Project: IEEE P802.15 Working Group for Wireless Personal Area Networks (WPANs)

Submission Title: [Superframe resolution]

Re: [In response to TG3c comments (IEEE P802.15-08-0020-05-003c)]

Abstract: [Comment resolutions]

-Superframe resolution-

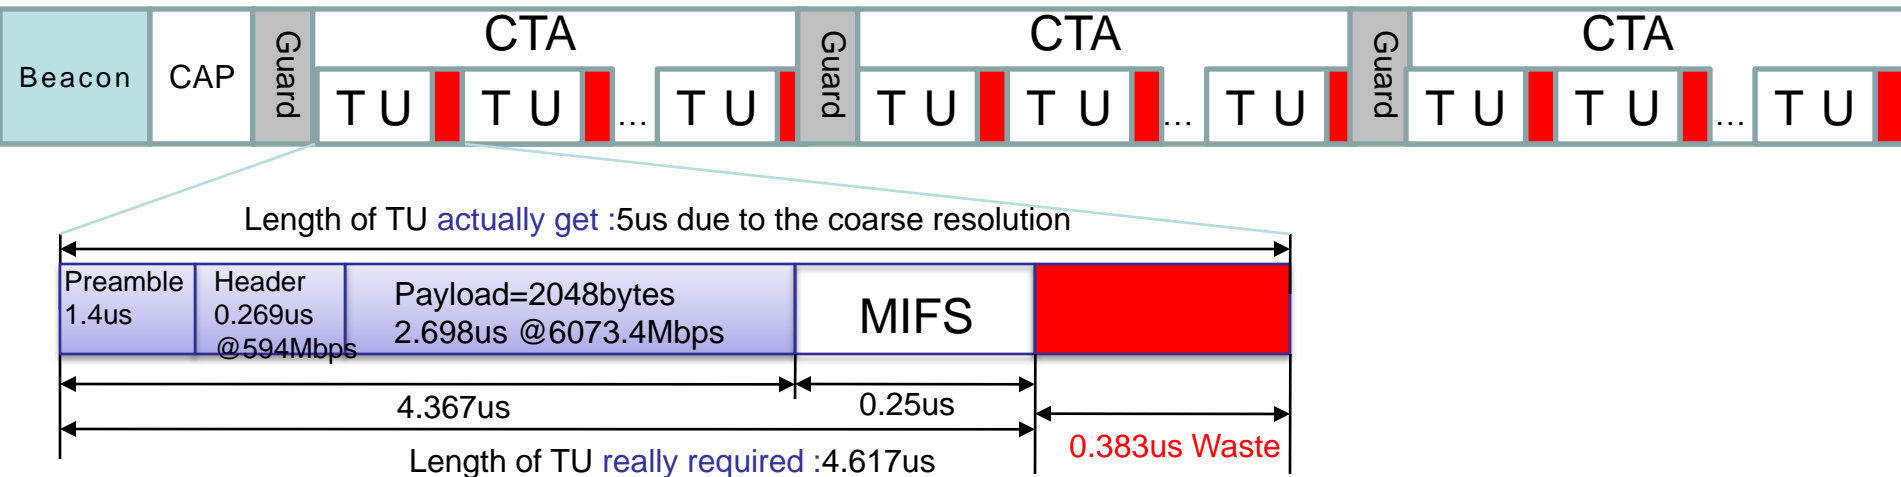
- Comment
 - Does the resolution of the superframe timing need to be less than $1\mu s$?”
- Answer
 - No, There is no need to change super frame resolution.

Overhead in beacon to support high resolution TU

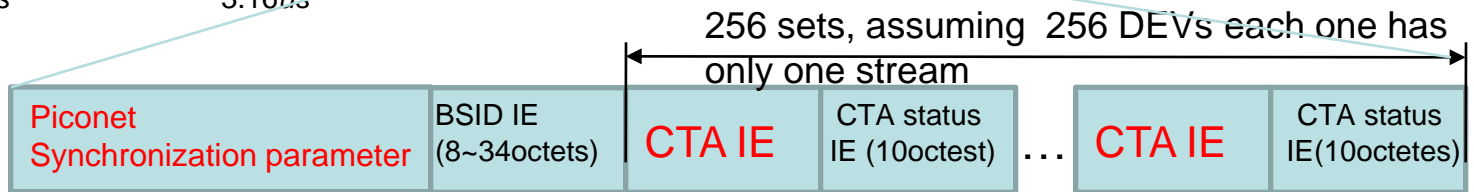
- Comment
 - It is suggested to increase TU resolution from 1us to 160ns, frame size resolution from 1 octet to 2 octets
- Answer
 - To improve throughput of short frame transmission, A high resolution TU is suggested
 - Assuming 2Kbytes data transmission at 6Gbps, up to 10% throughput improvement can be achieved by increasing resolution from 1us to approximate 160ns (32*8 symbols) with negligible overhead in beacon

- Overhead for increased resolution is negligible
 - Less than 1% superframe time is paid (Only need to extend 10.9 % beacon length to support up to 256 DEVs)

Increase from 21 octets to 23 octets

Increase from 7 octets to 9 octets for each CTA block

Up to $2 + 256 * 2 = 514$ octets are required
